Service Bulletin No. 446B

MODEL J4500	TYPE Field Change Program	SECTION/GROUP 3-Body	DATE June 19, 2017
SUBJECT A/C COMPRESSOR SUPPORT TUBE			
CONDITIONS

THIS BULLETIN SUPERCEDES SERVICE BULLETIN 446 IN ITS ENTIRETY.

Figure 3. Idler pulley bracket angle drilled mounting hole dimensions.

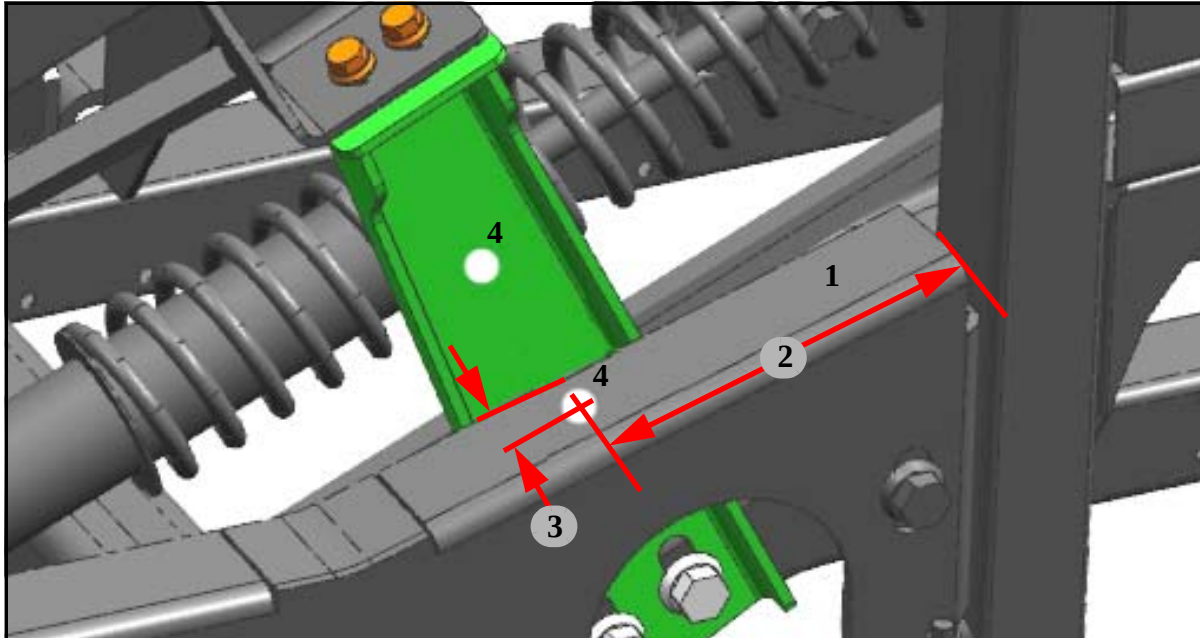
5. Locate the existing snubber bracket assembly shown in Figure 3. Remove and discard the existing snubber bracket and mounting hardware. Retain the idler pulley to be re-installed at a later step in this procedure.
6. Using a 17/32 inch drill bit and a drill, drill a mounting hole in the tie bar plate per the dimensions shown in Figure 3.

Item	Figure 3 Description
1	Tie bar plate
2	6.00 inch
3	0.87 inch
4	Mounting holes

Figure 4. Idler pulley bracket angle and snubber bracket installation.

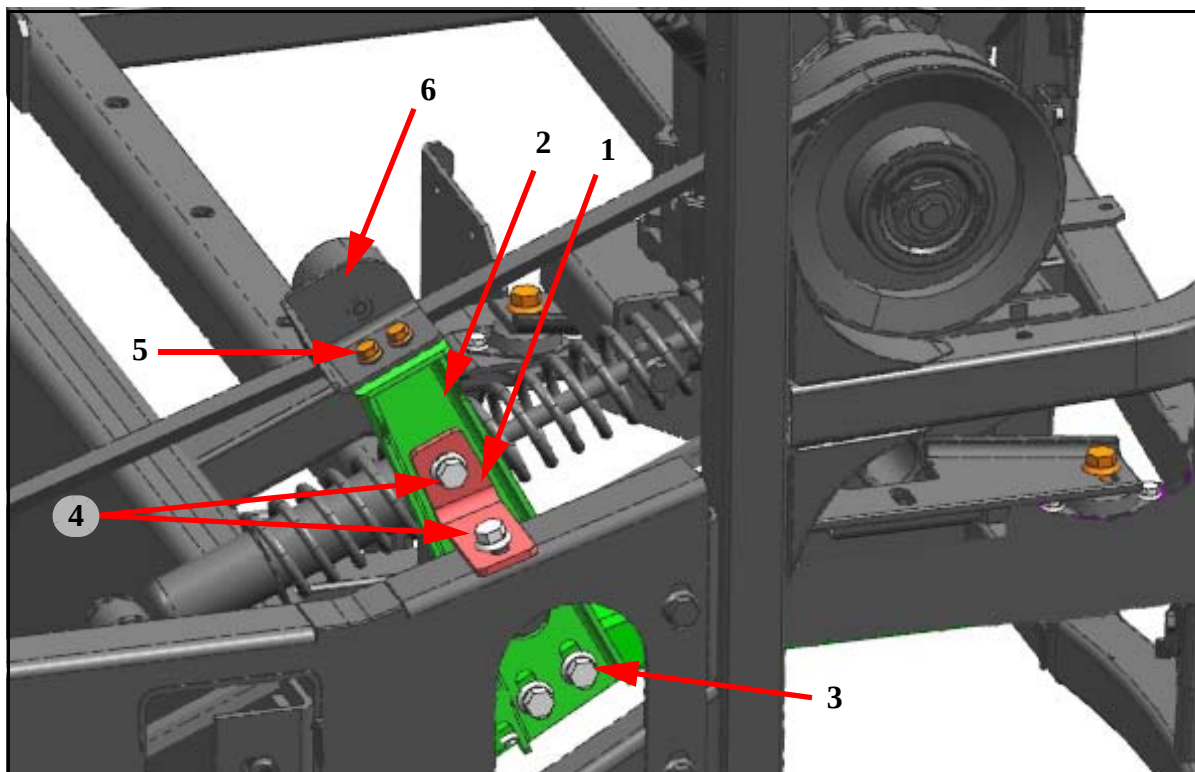
7. Orient and install the new snubber bracket, p/n 08-27-1327, idler pulley bracket angle, p/n 08-27-1326, and existing idler pulley as shown in Figure 4.

Item	Figure 4 Description
1	Angle, idler pulley bracket
2	Snubber bracket
3	Snubber bracket cap screw, p/n 19-01-1526 and flange nut, p/n 19-03-0497. Torque to 77-93 ft.-lbs
4	Angle cap screw, p/n 19-01-1577 and flange nut, p/n19-03-0497. Torque to 77-93 ft.-lbs
5	Idler pulley cap screw, p/n 19-01-1570 and lock nut,19-03-0535. Torque to 43-47 ft.-lbs
6	Idler pulley

Figure 5. Addition of shim(s) to achieve a 3/8 inch belt deflection.

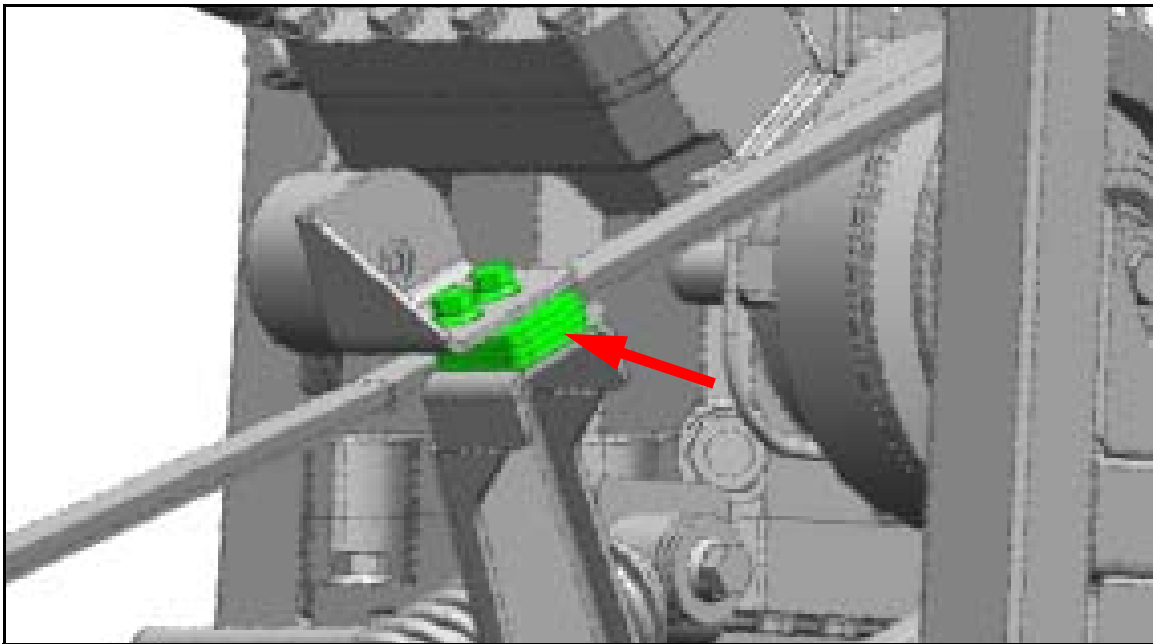
9. Remove the capscrew, p/n 19-01-1570 and lock nut, 19-03-0535 mounting the idler pulley to the snubber bracket. Orient and position the shims, p/n 08-27-1324, between the idler pulley bracket and the snubber bracket (refer to Figure 5).
10. Orient and install new capscrews, p/n 19-01-1736, through the idler pulley holes and the shim(s). Install the locknuts, p/n 19-03-0535, on the capscrews. Torque to 43-47 ft-lbs.

Figure 15. Weld information for support plates.

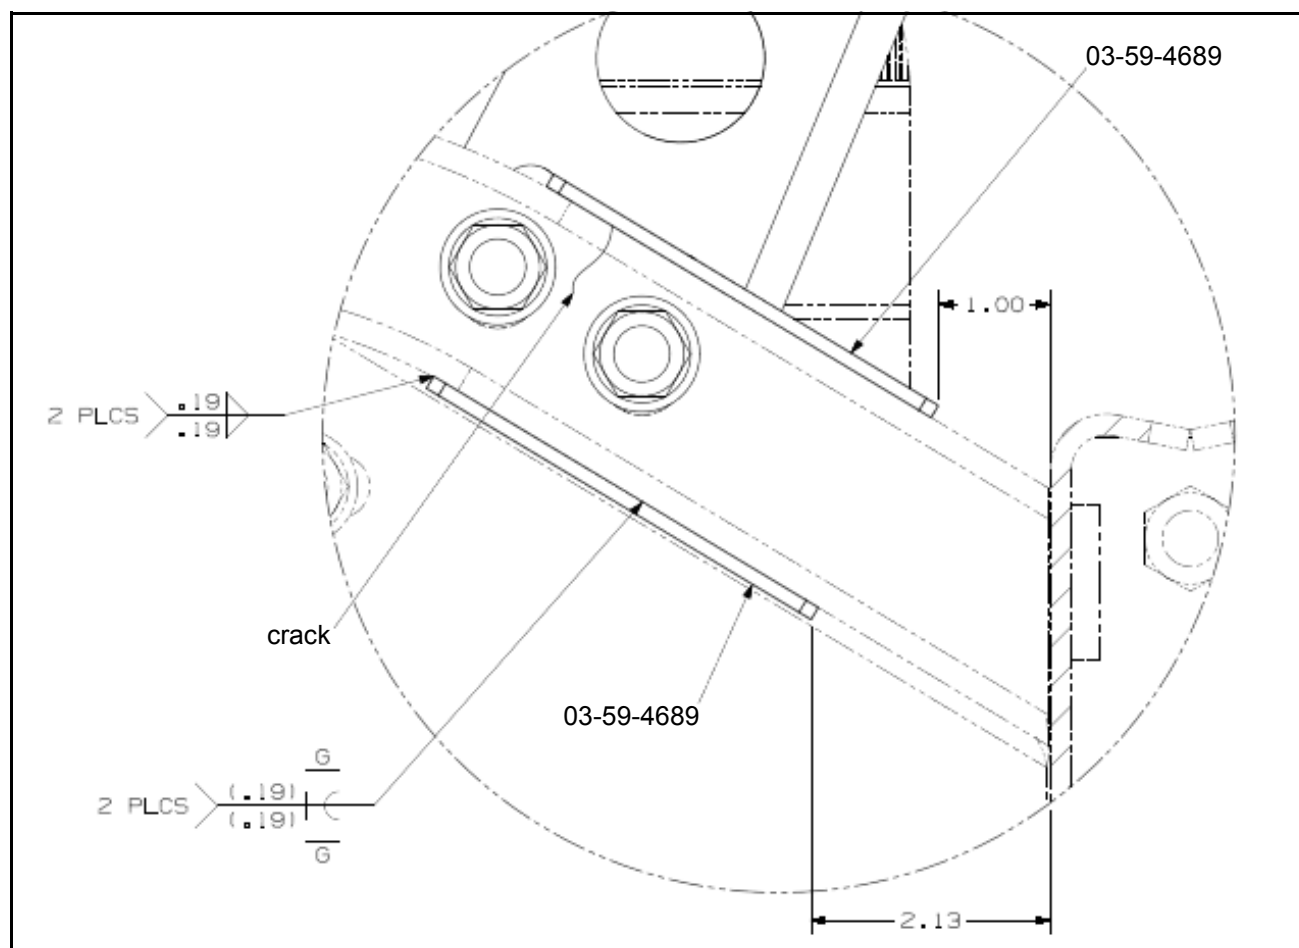
27. Perform the weld disconnect procedure.
28. Locate the existing snubber bracket assembly. Remove and discard the existing snubber bracket and mounting hardware. Retain the idler pulley to be re-installed at a later step in this procedure.
29. Drill a 0.125 diameter hole at both extreme ends of the crack. V-grind along the entire length of the crack. Fill drilled holes and v-grind with weld.
30. Orient and weld the support plates, p/n 03-59-4689, as shown in Figure 15.

Figure 16. Idler pulley bracket angle drilled mounting hole dimensions.

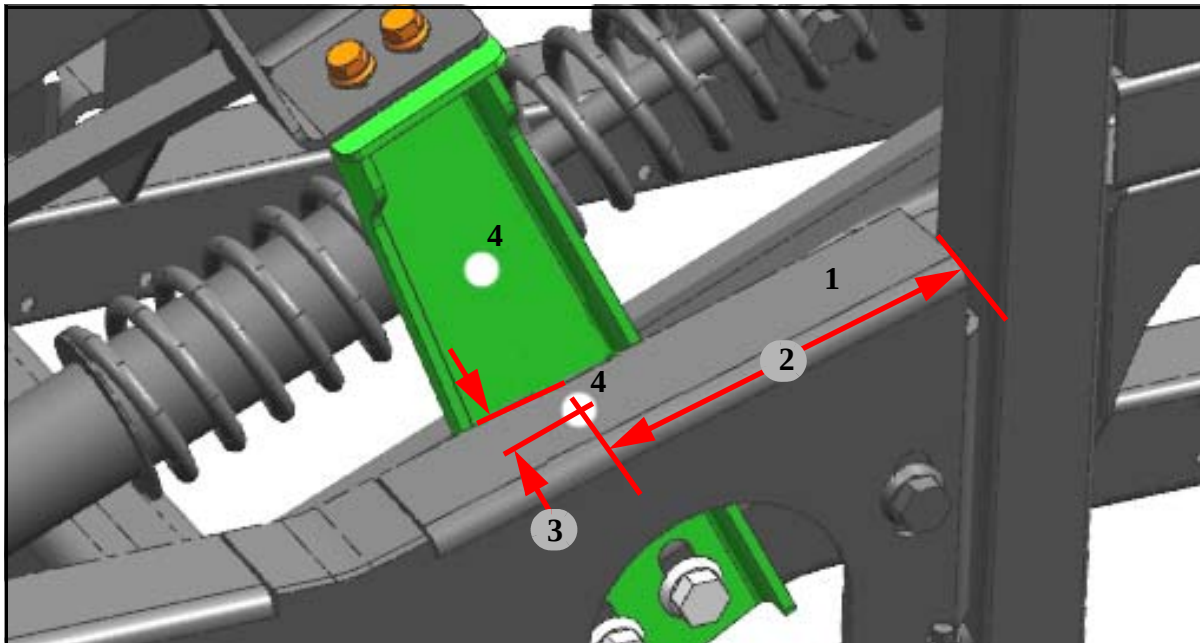
31. Using a 17/32 inch drill bit and a drill, drill a mounting hole in the tie bar plate per the dimensions shown in Figure 16.

Item	Figure 16 Description
1	Tie bar plate
2	6.00 inch
3	0.87 inch
4	Mounting holes

Figure 17. Idler pulley bracket angle and snubber bracket installation.

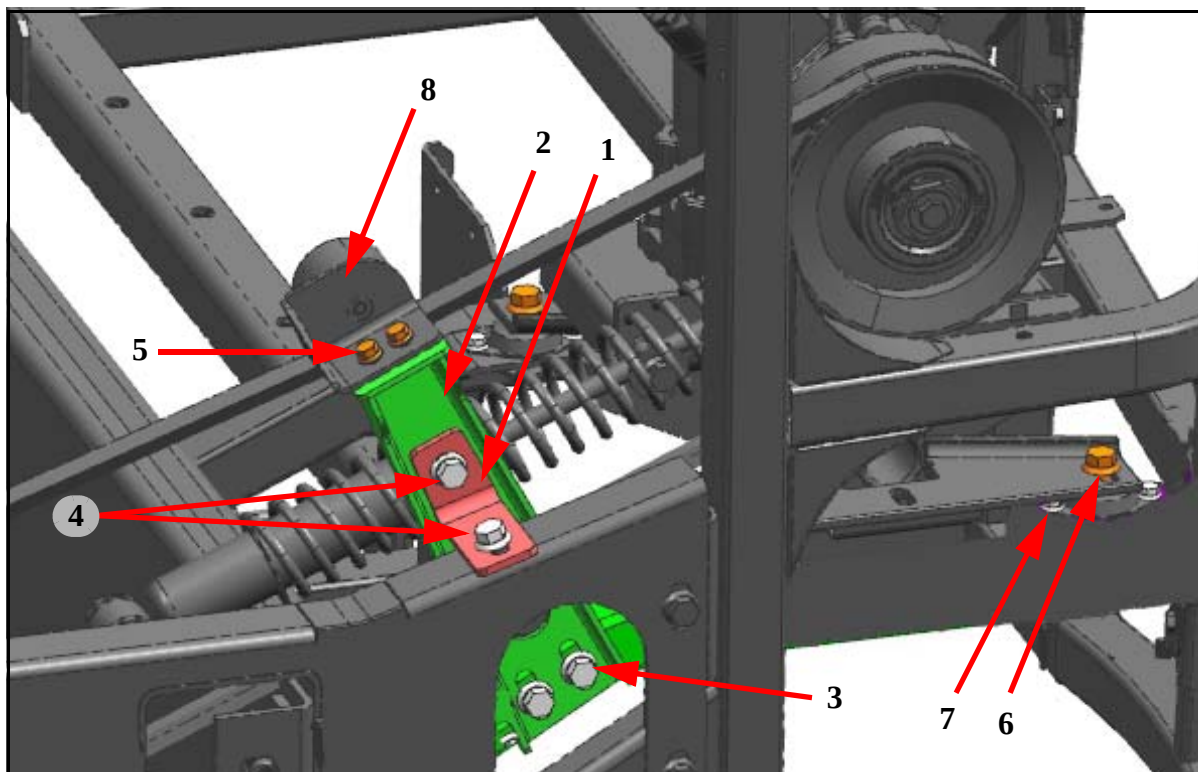
32. Orient and install the new snubber bracket, p/n 08-27-1327, idler pulley bracket angle, p/n 08-27-1326, and existing idler pulley as shown in Figure 17.

Item	Figure 17 Description
1	Angle, idler pulley bracket
2	Snubber bracket
3	Snubber bracket cap screw, p/n 19-01-1526 and flange nut, p/n 19-03-0497. Torque to 77-93 ft.-lbs
4	Angle cap screw, p/n 19-01-1577 and flange nut, p/n 19-03-0497. Torque to 77-93 ft.-lbs
5	Idler pulley cap screw, p/n 19-01-1570 and lock nut, 19-03-0535. Torque to 43-47 ft.-lbs
6	Compressor stabilizer (pivot plate / Figure 14), ref p/n's 19-01-1529, 19-03-0497. Torque to 63-77 ft.-lbs
7	Stabilizer to brackets (pivot plate / Figure 14), ref p/n's 19-01-1532, 19-03-0498. Torque to 14-16 ft.-lbs
8	Idler pulley

Figure 18. Addition of shim(s) to achieve a 3/8 inch belt deflection.

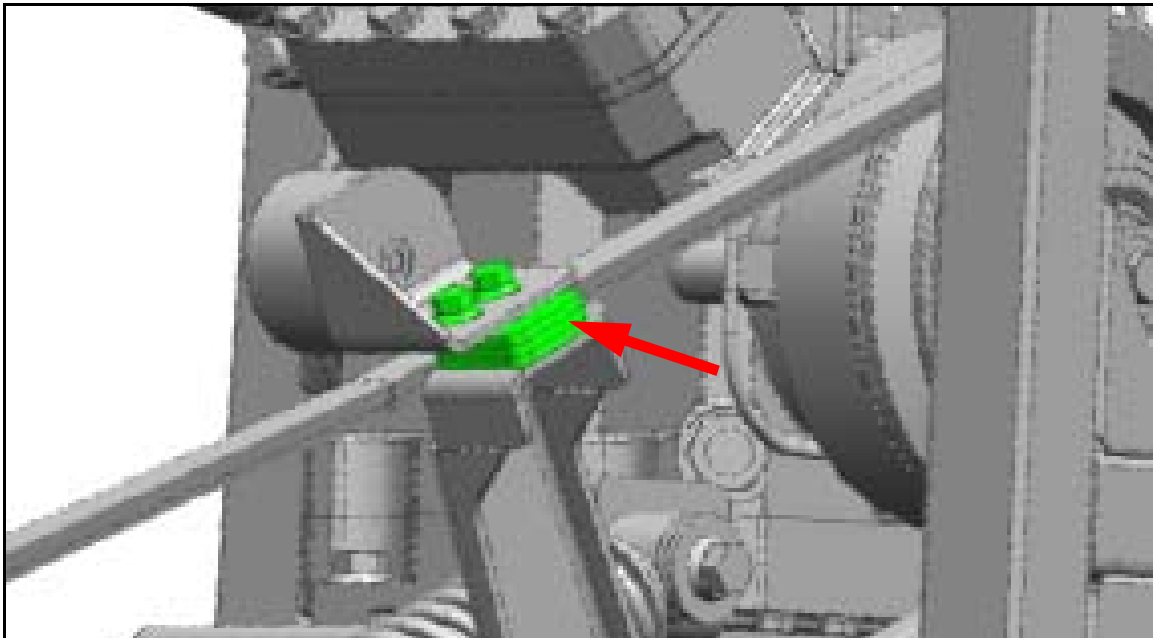
34. Remove the capscrew, p/n 19-01-1570 and lock nut, 19-03-0535 mounting the idler pulley to the snubber bracket. Orient and position the required quantity of shims, p/n 08-27-1324, between the idler pulley bracket and the snubber bracket (refer to Figure 18).
35. Orient and install new capscrews, p/n 19-01-1736, through the idler pulley holes and the shim(s). Install the locknuts, p/n 19-03-0535, on the capscrews. Torque to 43-47 ft-lbs.

Figure 31. Weld information for new tube assembly.

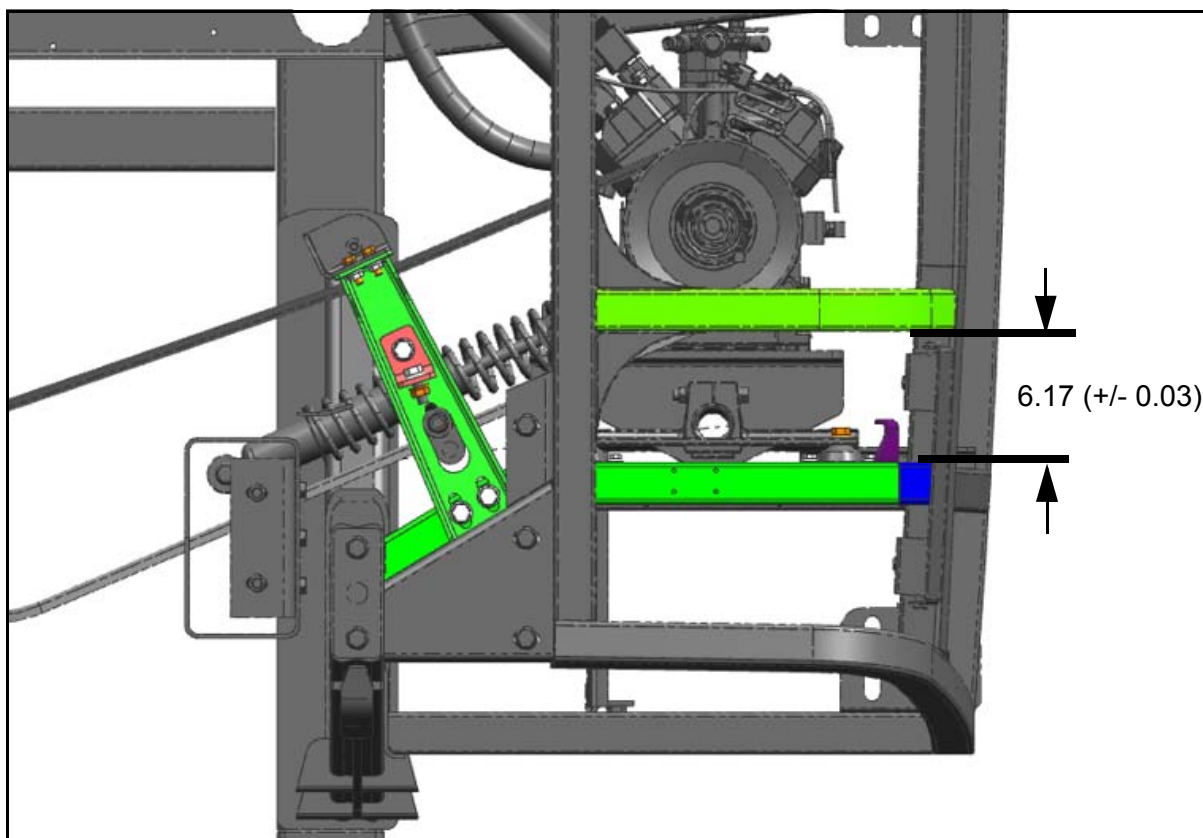
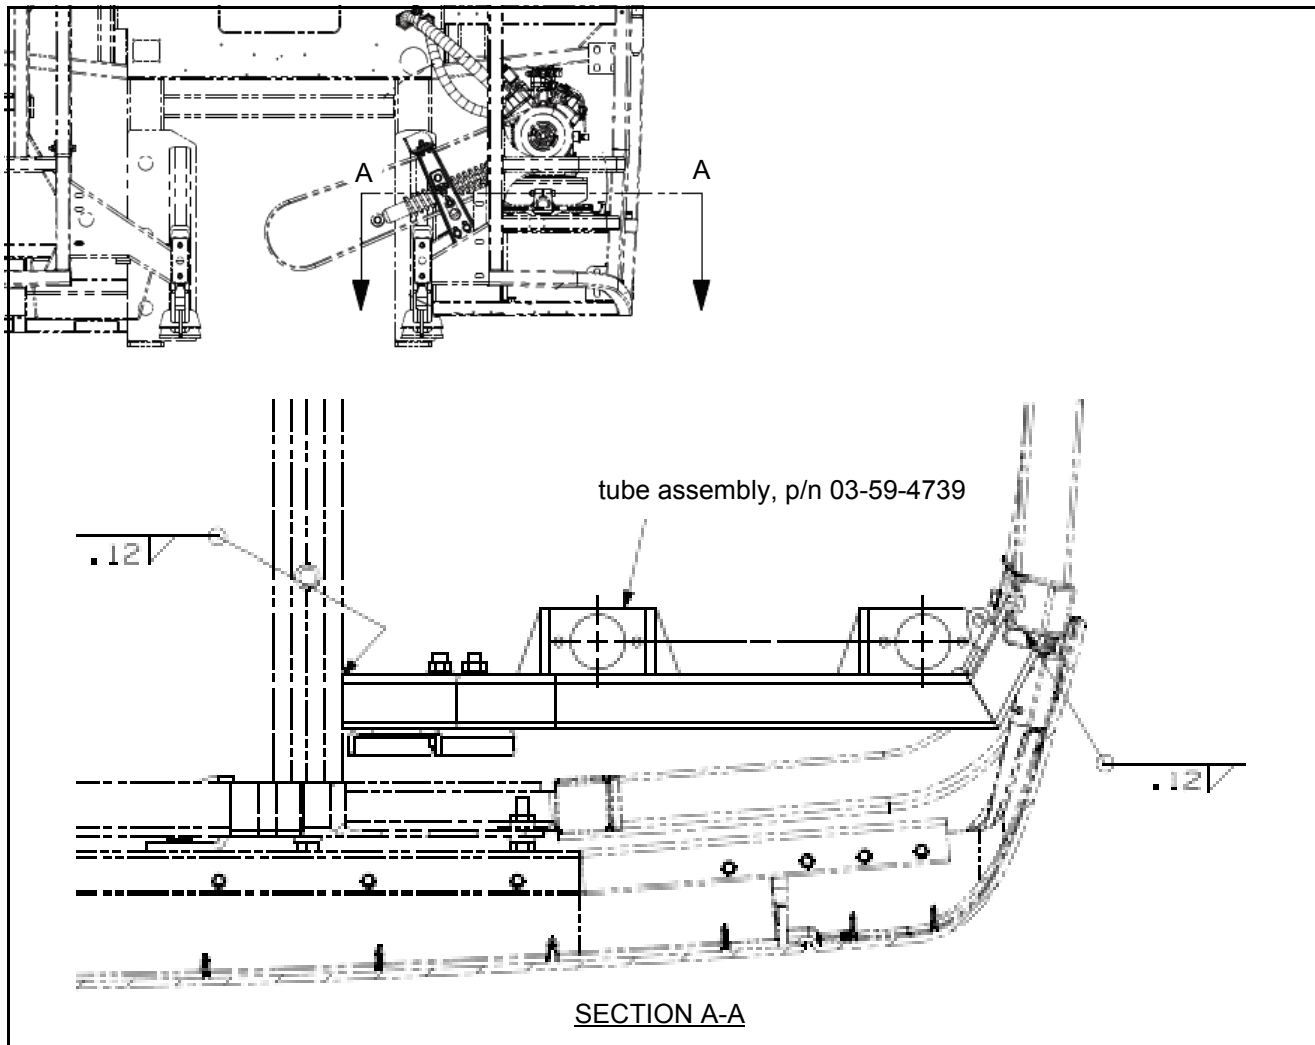
67. Perform the weld disconnect procedure.
68. Carefully cut and grind away existing cracked support tube shown in Figures 30 and 31.
69. Orient and weld the new tube assembly, p/n 03-59-4739, to the existing structure and engine rail as shown in Figures 30 and 31.

Figure 32. Idler pulley bracket angle drilled mounting hole dimensions.

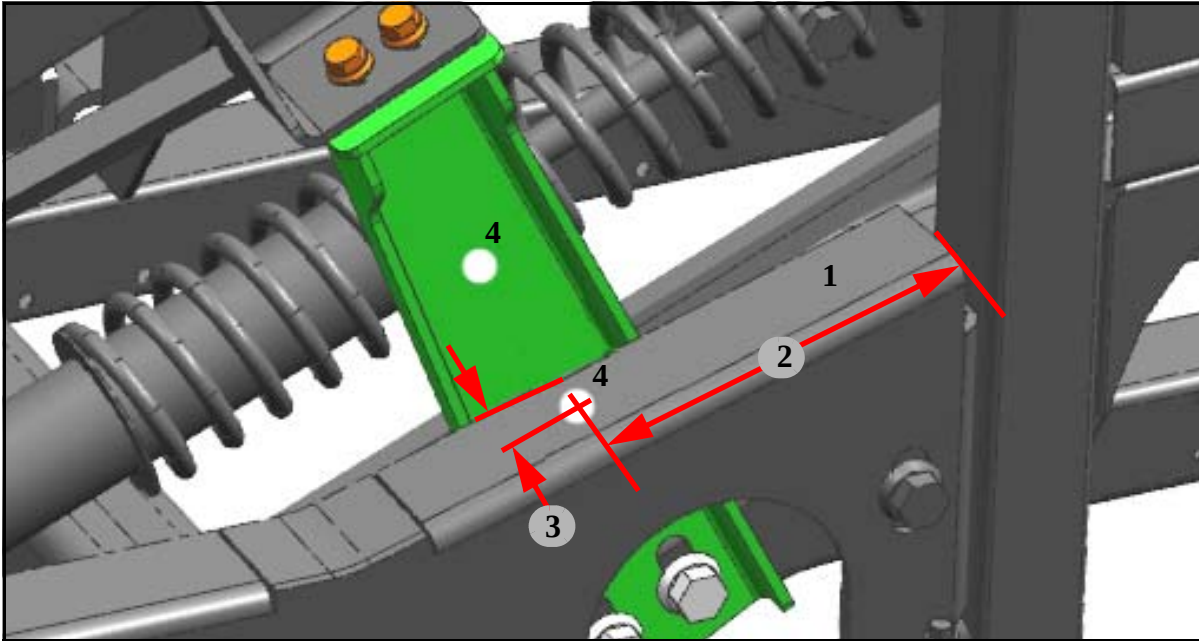
70. Using a 17/32 inch drill bit and a drill, drill a mounting hole in the tie bar plate per the dimensions shown in Figure 32.

Item	Figure 32 Description
1	Tie bar plate
2	6.00 inch
3	0.87 inch
4	Mounting holes

Figure 33. Idler pulley bracket angle and snubber bracket installation.

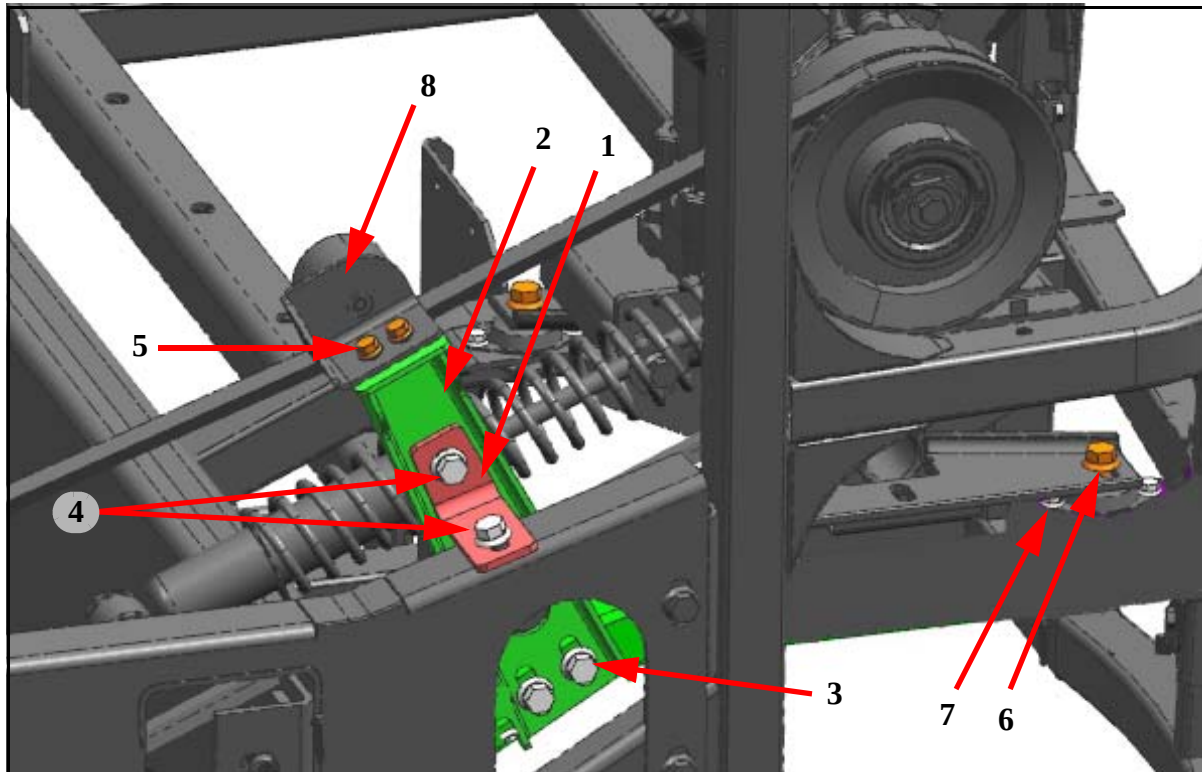
71. Orient and install the new snubber bracket, p/n 08-27-1327, idler pulley bracket angle, p/n 08-27-1326, and existing idler pulley as shown in Figure 33.

Item	Figure 33 Description
1	Angle, idler pulley bracket
2	Snubber bracket
3	Snubber bracket cap screw, p/n 19-01-1526 and flange nut, p/n 19-03-0497. Torque to 77-93 ft.-lbs
4	Angle cap screw, p/n 19-01-1577 and flange nut, p/n 19-03-0497. Torque to 77-93 ft.-lbs
5	Idler pulley cap screw, p/n 19-01-1570 and lock nut, 19-03-0535. Torque to 43-47 ft.-lbs
6	Compressor stabilizer, ref p/n's 19-01-1529, 19-03-0497. Torque to 63-77 ft.-lbs
7	Stabilizer to brackets, ref p/n's 19-01-1532, 19-03-0498. Torque to 14-16 ft.-lbs
8	Idler pulley
